SERVICE

1554B TELEPHONE SETS

1.01 Reissued to:

♦ Fig. 1—1554B (MD) Telephone Set, Connections With 25W3 (MD) Dial ♦

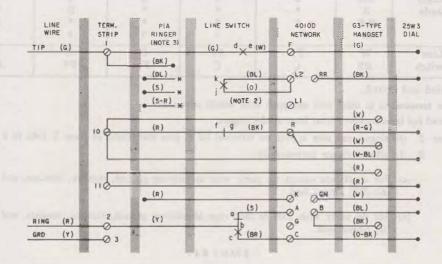
Show (BL) lead removed from later model ringers

J-K AND ASSOCIATED (0) AND (BL) LEADS.
- * INSULATED AND STORED
- 3. (BL) LEAD HAS BEEN REMOVED FROM LATE MODEL RINGERS.
